MODIFICATION #6  
WEST LILAC ROAD (EAST OF EASTERLY ROUNDABOUT)

Request for a  
Modification to a Road Standard  
and/or to Project Conditions

Project Number: TM 5571/5572 Date of Request: January 31, 2014

# ATTACHMENT 1

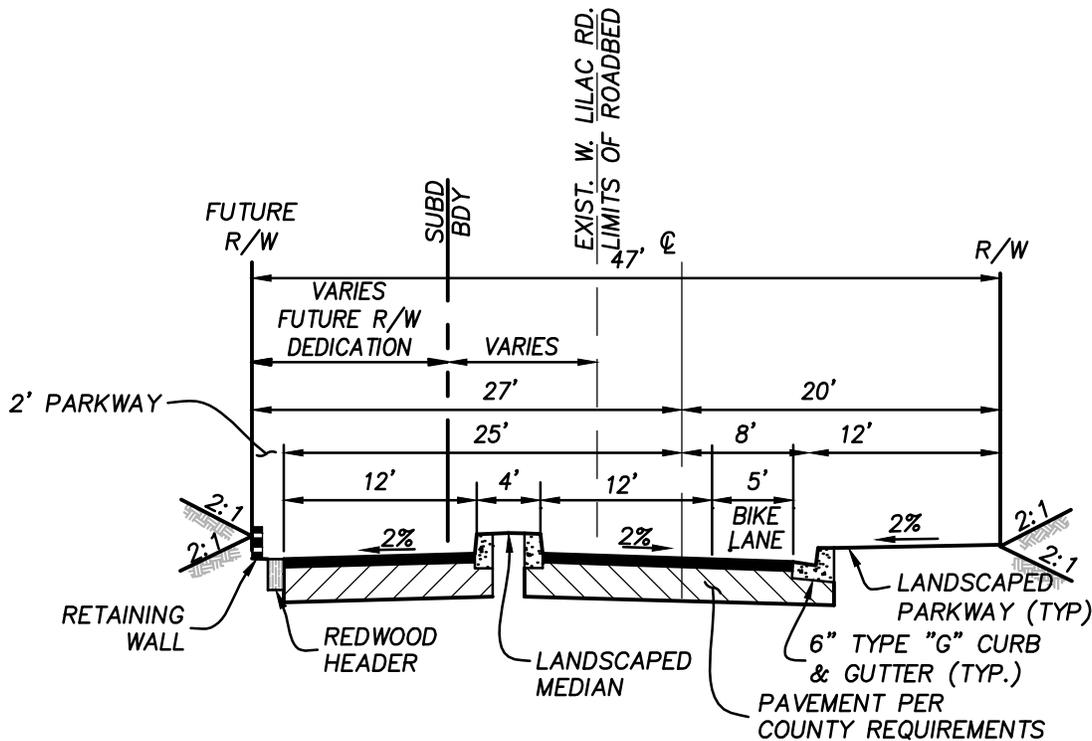
The requested road modification pertains to exist W. Lilac Road, East of the proposed  
Easterly roundabout. There is no existing right-of-way for West Lilac Road. Existing W.  
Lilac Road in this area has a pavement width of 20'-24' wide see (Attachment 1). The request  
is to improve the Southerly portion of the road (plus 12' additional pavement on the North)  
within the project boundary and within the prescriptive rights the public has to existing  
West Lilac Road to current County standard 2.2F so that we can keep the disturbance to adjacent  
property owners to a minimum. This will also allow us to transition to the existing pavement  
of West Lilac Road east of the project boundary without condemning additional offsite  
right-of-way and disrupting existing access points to adjacent properties.

# ATTACHMENT 2 WITH MODIFICATION #6 LILAC HILLS RANCH: 2.2F LIGHT COLLECTOR

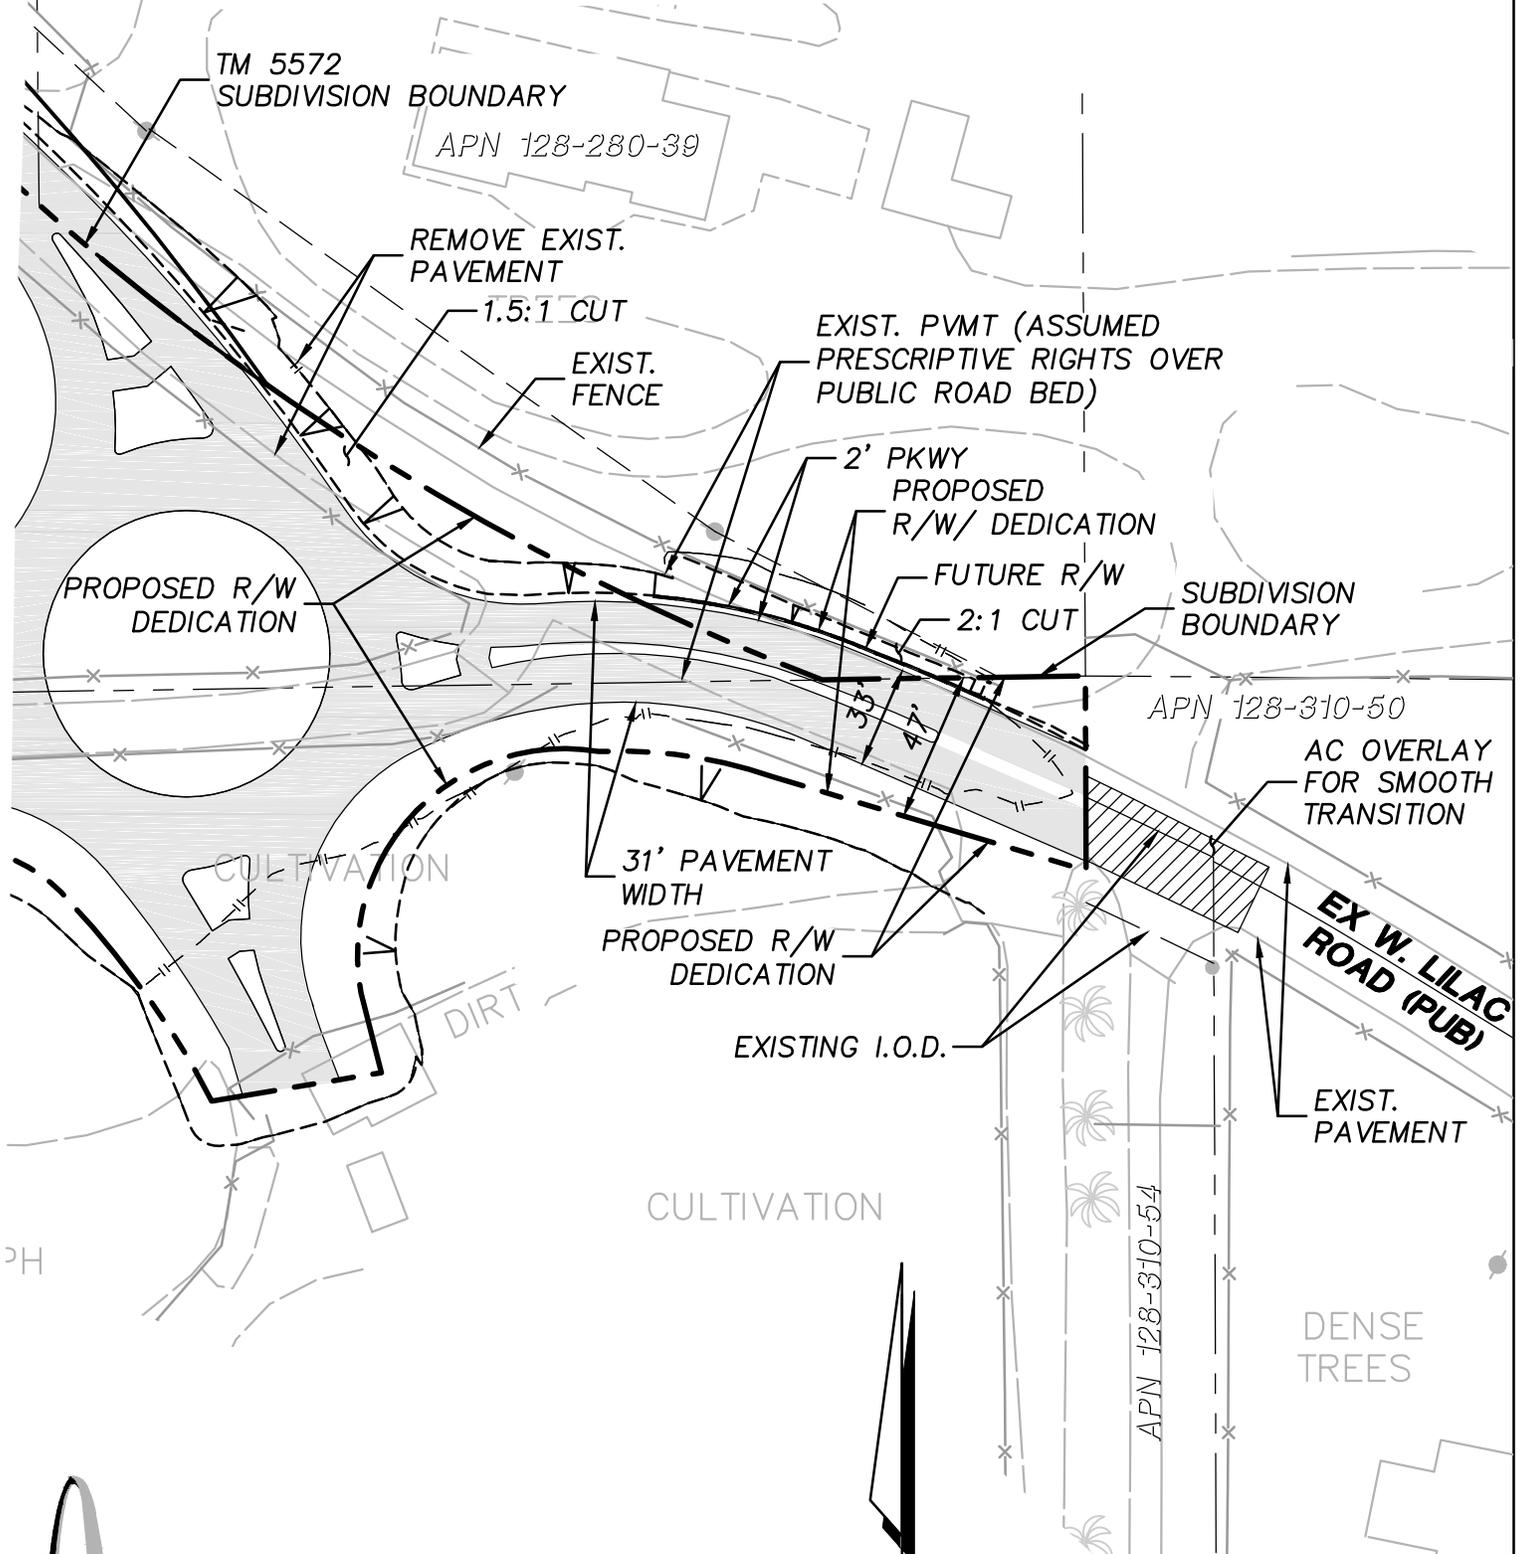
The standard road section for Light Collector 2.2F requires 28' road surfacing width,  
52' ROW, 2' shoulder, and 12' parkway. We propose to improve this roundabout approach with a 4'  
splitter island and 12' travel lane, 5' bike lane and full 12' pkwy along south and 12' travel lane  
and no shoulder and reduced 2' pkwy along the north.

See Attachment 2 for road design with modification.
